[BOND BEAM HEAT TRANSFER]

Written by, Dale W. Feb

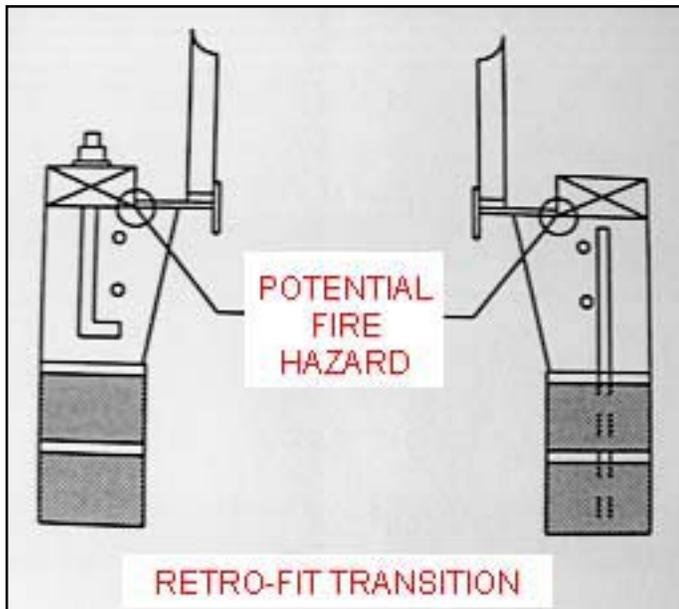
The problem is located at the contact point between the wood sill plate and the newly constructed bond beam. Attempting to build the framed chimney shaft the same width and depth as the existing masonry

chimney produces a very small bond beam. In many instances the bond beam is so small that the bottom wood plate is trimmed in order to meet the clearance requirements of the listed metal chimney pipe. Under most conditions the thickness of the bond beam that the heat is to travel through may be as thin as two inches. This condition will allow the heat to transfer through the bond beam to the wood sill plate. In time, pyrolysis to the wood may occur, and eventually fire, therefore defeating the purpose of the clearance requirements.

This process of heat transfer through the bond beam is increased by the reduction in air speed of the heated gases at the transition from smoke chamber to listed round flue pipe. This is again compounded by the fact that many of the transitions are more than 45 degrees from vertical and do not conform to the "uninterrupted" requirement stated in L.A. City details.

The requirement for a steel "only" chimney shaft would eliminate this potential fire hazard.
